Subject: Western Star 4700 Forward Rear Axle Wiring

Models Affected: Specific Western Star 4700 model vehicles,
manufactured December 21, 2012, through May 17, 2013.

Daimler Trucks North America LLC, on behalf of its wholly owned subsidiary, Western Star Trucks Sales, Inc., is initiating Field Service Campaign SF490A to modify the vehicles mentioned above.

February 2014
SF490A

Fig. 1, Rear Axle Harness Locations

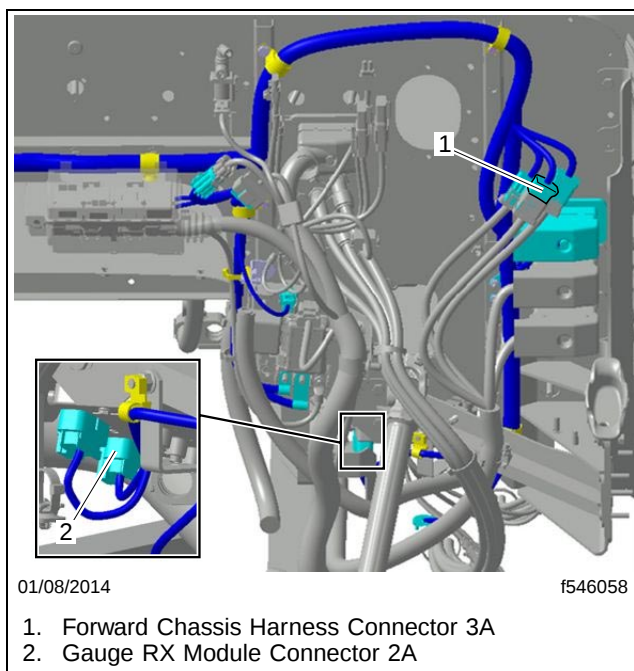
5. Disconnect the forward chassis harness connector 3A. See **Fig. 1**.

Fig. 2, Forward Chassis Harness Connector 3A

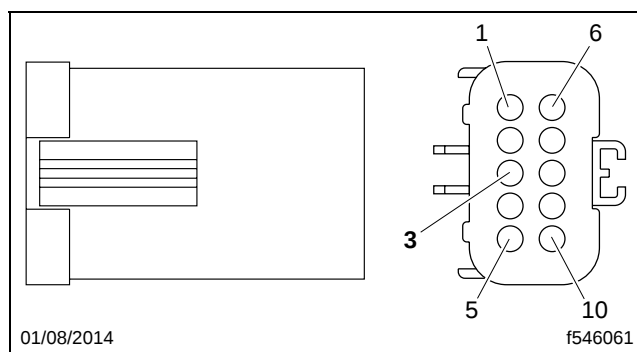
6. Remove the terminal lock from connector 3A.
7. Insert the male terminal (23-13211-011) end of the new wire into cavity 3 on the forward chassis harness connector 3A. See **Fig. 2**.

Fig. 3, Gauge RX Module Connector 2A

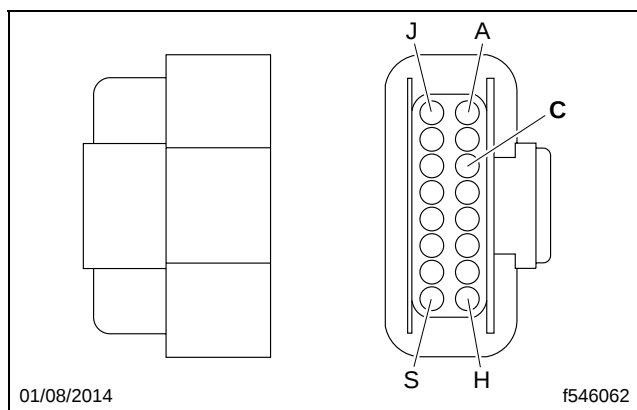
8. Attach the terminal lock and connect the connector.
9. Disconnect the Gauge RX module connector 2A. Remove the terminal lock, then remove the plug from cavity C.
10. Insert the female terminal (23-13212-020) end of the new wire into cavity C on the gauge RX module connector 2A. See **Fig. 3**.
